Well Name: POKER LAKE UNIT 15 TWR	Well Location: T24S / R31E / SEC 22 / NENW / 32.208728 / -103.766951	County or Parish/State: EDDY / NM
Well Number: 213H	Type of Well: OIL WELL	Allottee or Tribe Name:
Lease Number: NMNM0506A	Unit or CA Name: POKER LAKE UNIT	Unit or CA Number: NMNM71016X
US Well Number: 3001554180	Operator: XTO PERMIAN OPERATING LLC

Sundry ID: 2823628

Type of Action: APD Change

PECOS DISTRICT DRILLING CONDITIONS OF APPROVAL

ACREAGE DEDICATION PLATS

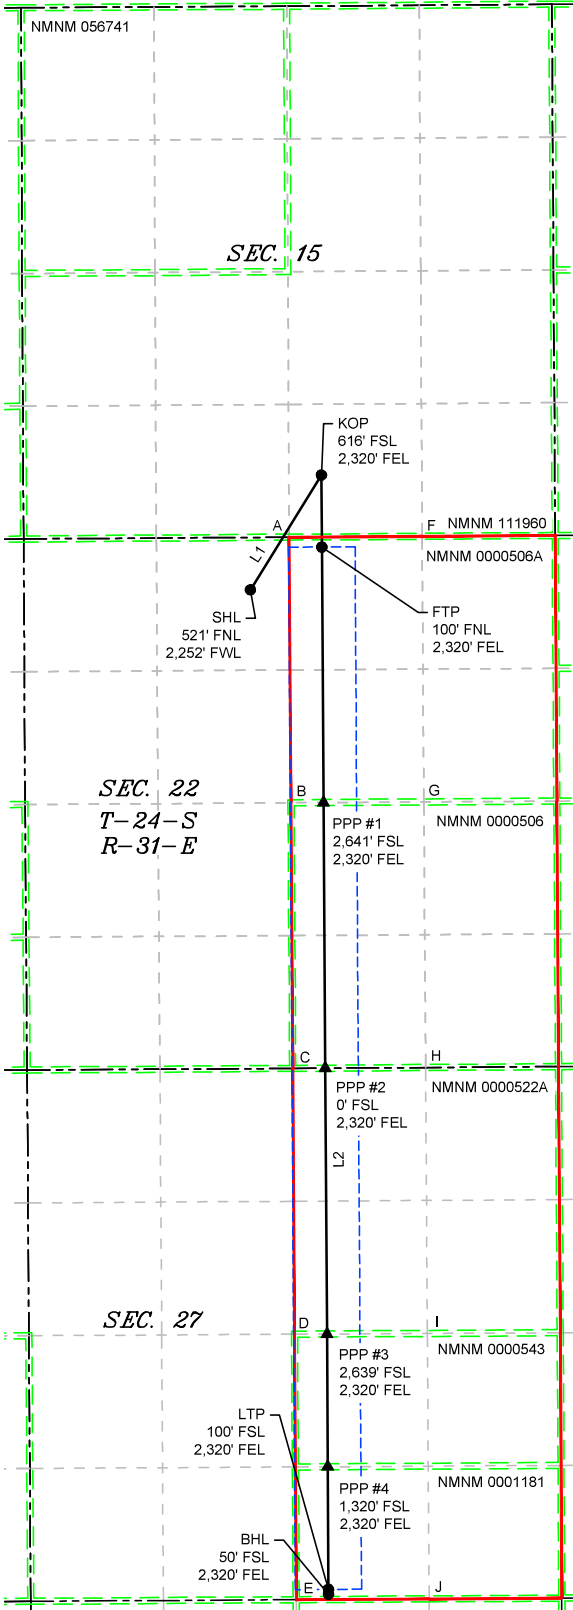
XTO Permian Operating, LLC. respectfully requests approval to make the following changes to the approved APD. Changes to include SHL, KOP, FTP, LTP, BHL, Proposed total Depth, and Pool. There is no new surface disturbance.

FROM: TO:
SHL: 501' FNL & 2252' FWL OF SECTION 22-T24S-R31E 521' FNL & 2252' FWL OF SECTION 22-T24S-R31E
KOP: 501 FNL & 2252 FWL OF SECTION 22-T24S-R31E 616 FSL & 2320 FEL OF SECTION 15-T24S-R31E
FTP: 330' FNL & 1870' FWL OF SECTION 22-T24S-R31E 100' FNL & 2320' FEL OF SECTION 22-T24S-R31E
LTP: 2540' FNL & 1870' FWL OF SECTION 34-T24S-R31E 100' FSL & 2320' FEL OF SECTION 27-T24S-R31E
BHL: 2590' FNL & 1870' FWL OF SECTION 34-T24S-R31E 50' FSL & 2320' FEL OF SECTION 27-T24S-R31E

The proposed total depth is changing from 24032 MD; 10863 TVD to 20539 MD; 9543 TVD.

UL	Section	Township	Range	Lot	Ft. from N/S	Ft. from E/W	Latitude	Longitude	County
C	22	24S	31E		521 FNL	2,252 FWL	32.208673	-103.766951	EDDY

UL	Section	Township	Range	Lot	Ft. from N/S	Ft. from E/W	Latitude	Longitude	County
O	27	24S	31E		50 FSL	2,320 FEL	32.181206	-103.764613	EDDY

UL	Section	Township	Range	Lot	Ft. from N/S	Ft. from E/W	Latitude	Longitude	County
O	15	24S	31E		616 FSL	2,320 FEL	32.211801	-103.764648	EDDY

UL	Section	Township	Range	Lot	Ft. from N/S	Ft. from E/W	Latitude	Longitude	County
B	22	24S	31E		100 FNL	2,320 FEL	32.209832	-103.764646	EDDY

UL	Section	Township	Range	Lot	Ft. from N/S	Ft. from E/W	Latitude	Longitude	County
O	27	24S	31E		100 FSL	2,320 FEL	32.181343	-103.764613	EDDY
